Device TC36x
Marking/Step (E)ES-AA, AA
Package see Data Sheet

10298AERRA

This Errata Sheet describes the deviations from the current user documentation.

Figure 2 Message buffer transfer from Message RAM to OBF

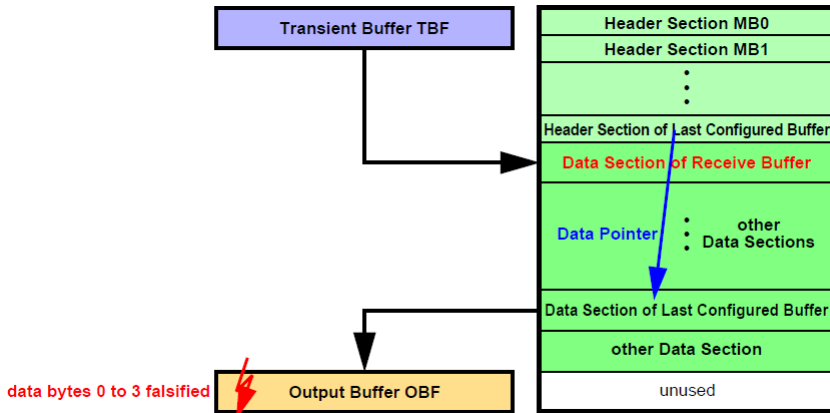
a) When a message is transferred from the Last Configured Buffer in the Message RAM to the OBF and **PLC** = 127 it may happen, that at the end of the transfer the OBF word on address 00h (payload data bytes 0 to 3) is overwritten with unexpected data (see [Figure 2](#)).

Figure 3 Message buffer transfer from IBF to Message RAM

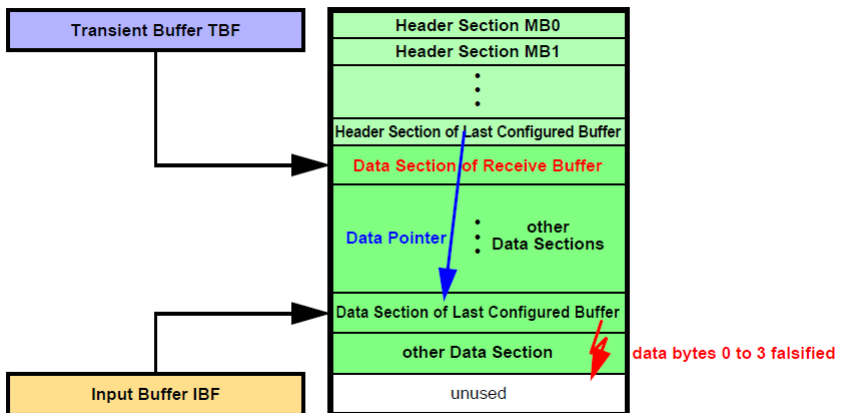
b) When a message is transferred from IBF to the Last Configured Buffer in the Message RAM, it may happen, that at the end of the transfer of the Data Section one additional write access overwrites the following word, which may be the first word of another message's Data Section in the Message RAM (see [Figure 3](#)).

Figure 4 Message RAM Configurations

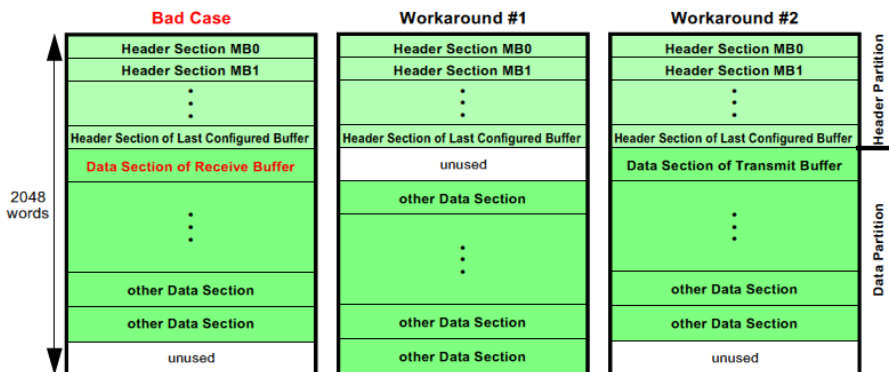
The erratum is limited to the case when (see [Figure 4](#) “Bad Case”):

2) Ensure that the Data Section directly following the Header Partition is assigned to a transmit buffer.

Figure 7 Critical MCS AEI master scenario

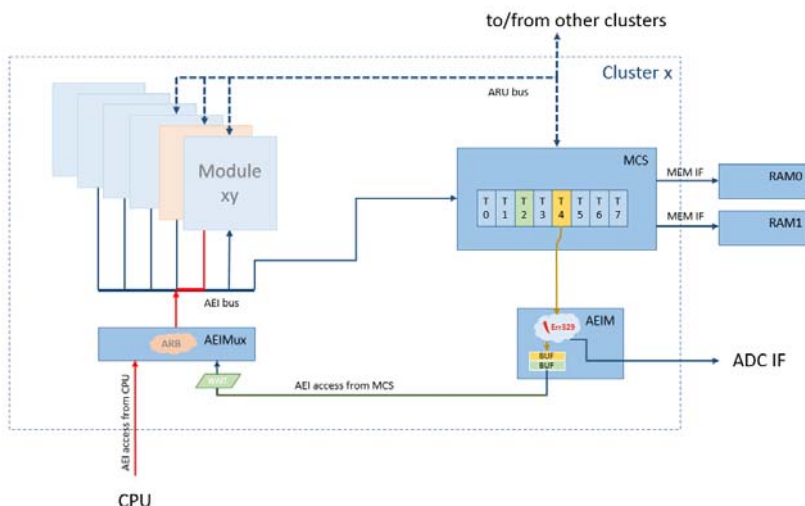
In [Figure 7](#), a potential risk for the occurrence of problem GTM_AI.329 is illustrated. Here the first buffer of the AEIM (green) is still waiting for the access to the AEI bus while a second AEI bus access from MCS arrives at the AEIM (yellow access path). Under certain, but for the user unpredictable timing conditions, this second AEI bus access arriving at the AEIM can trigger the misbehavior described in problem GTM_AI.329.

The workarounds described in the following section will ensure that not more than one AEIM buffer will be filled and therefore the occurrence of problem GTM_AI.329 is avoided. All workarounds have been tested and proven correct.

Figure 8 MCS token mechanism

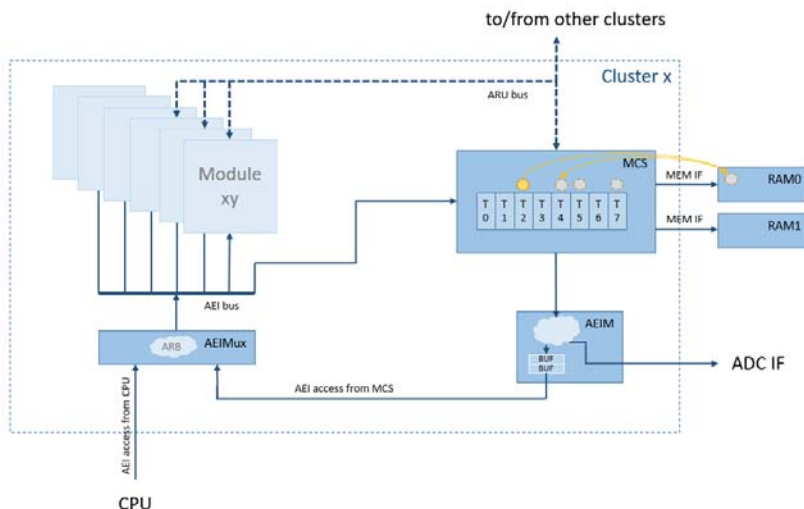
In case multiple MCS channels want to use the AEI master port for AEI or ADC communication, establish a mechanism that ensures that only one channel uses the AEI master at a time (e.g. exchange a token between channels or use trigger registers to hand over the AEI master port ownership between MCS channels).

An application note (AN020 – MCS Mutex implementation) describing a token exchange mechanism between MCS threads is available at Bosch. Such a token mechanism allows multiple MCS threads to safely access the AEI bus system by exchanging an AEI bus access token via MCS memory.

Figure 9 Equivalent Circuitry for Analog Inputs

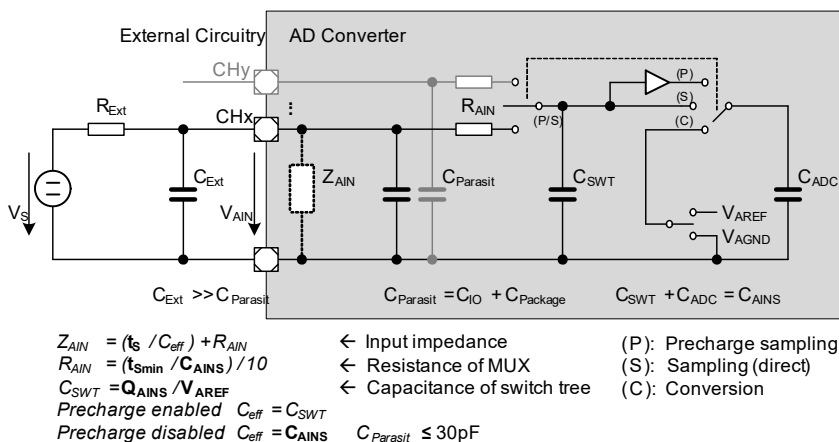
ADC_TC.P014 Equivalent Circuitry for Analog Inputs - Additional information

Figure “Equivalent Circuitry for Analog Inputs” will be modified in future revisions of the Data Sheet, including the term $C_{Parasit} \leq 30 \text{ pF}$, as shown in the following figure:

Figure 10 Interrupt Level vs. Pulse-Notify mode - Corner Case Example

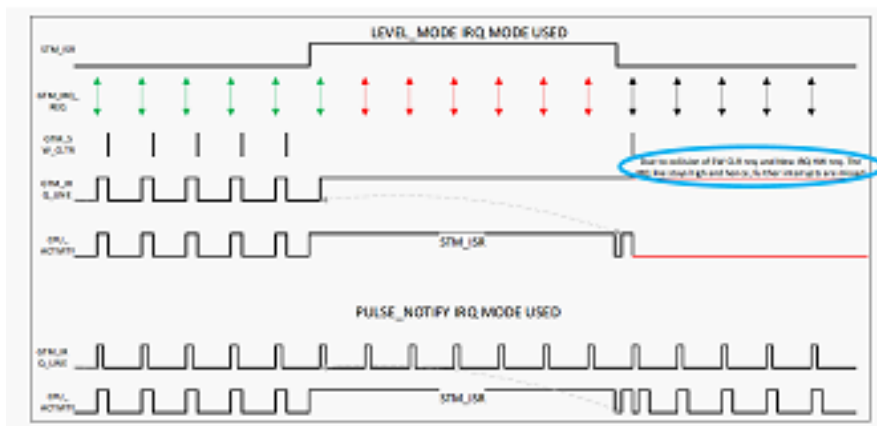
As described in the text below this figure, while using Level mode, if more internal “interrupt” events are generated (i.e. two TOM channels generating a CCU0 interrupt), just one interrupt signal is sent to the IR, and no more interrupts are triggered until the SW clears the GTM_IRQ_XXX line towards the IR.

Hence, in Level Mode, in some scenarios where another interrupt request is generated by GTM while the ISR handle also requests a SW clear, then, as the interrupt event is dominant over the clear event (for simultaneous interrupt and clear events), GTM_IRQ_XXX is not cleared and remains high. As a consequence, the IR observes no transition on GTM_IRQ_XX. Thus, any forthcoming interrupt events in this scenario are lost as there is no chance to release the CPU IRQ when a collision happens as shown in Figure below.

If Pulse-Notify mode is selected, every internal trigger will be forwarded to the IR, irrespective of the time of occurrence and the clear event, as the pulse-notify leads to set and reset of GTM_IRQ_XXX as compared to only setting of the GTM_IRQ_XXX line in Level mode.

Figure 12 Timing of LVDS TX interface command sending in relation to IRQ.IFCFS

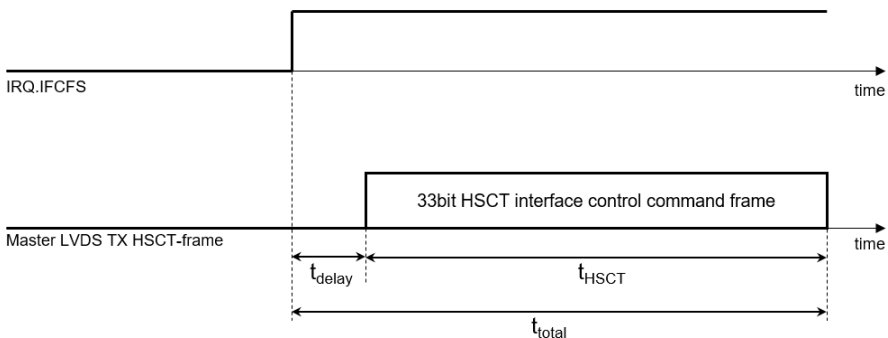
the user might falsely assume that also the actual sending on the LVDS TX port has already occurred once the IRQ.IFCFS flag is set, which is not true.

Instead the timing shown in **Figure 12** applies.
